SHOP DRAWING REVIEW

Job Number: 57517.00
 Reviewed By: S.E. BURBANK
 Date: 9/3/2015

F.R. LaFAYETTE,
BRIDGE 19
NORTH EAST CORNER
P/N: 0033.903951
MAT: A572 Gr. 50
QTY: 1 PCS.

WPS-3024

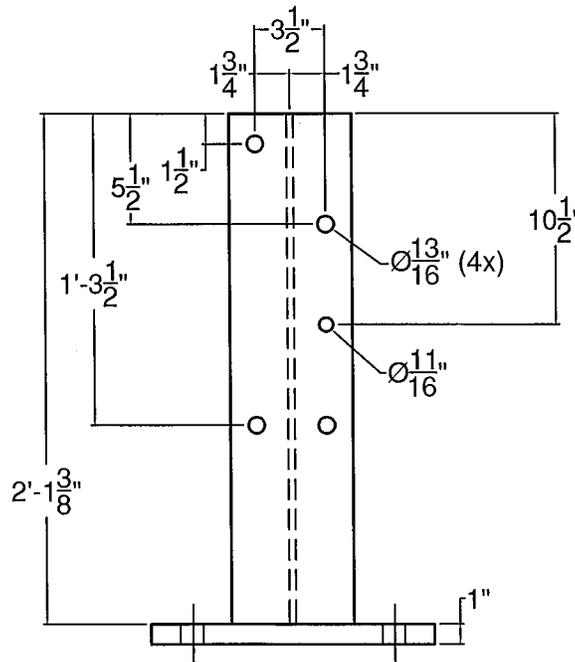
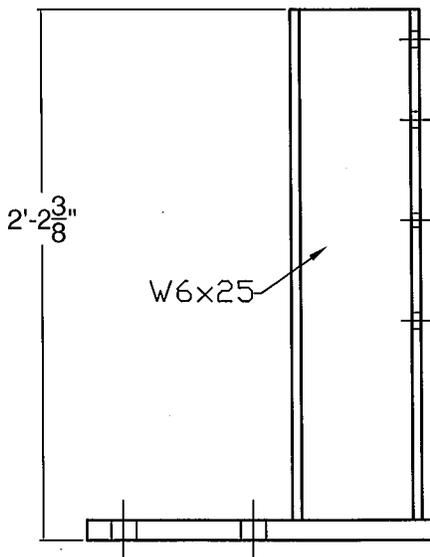
1. Please provide a plan view showing the bridge rail posts, face of curb, back of curb, anchor bolt locations. All features should be annotated and dimensions should be provided from the face of curb to the front face of the rail and to the base plates and back of curb.

2. Per our previous discussion, the southern bridge rail posts were to have offset blocks between the bridge rail and the bridge rail post. Please revise the details for the southern bridge rail to show offset blocks and keep the bridge rail post and bridge rail base plate per Standard S-360A.

3. Please provide a plan view showing the location of the bridge rail components on pages 3 through 5 of the shop drawing submittal. We will also need the contractor to submit welding procedures for all welds.
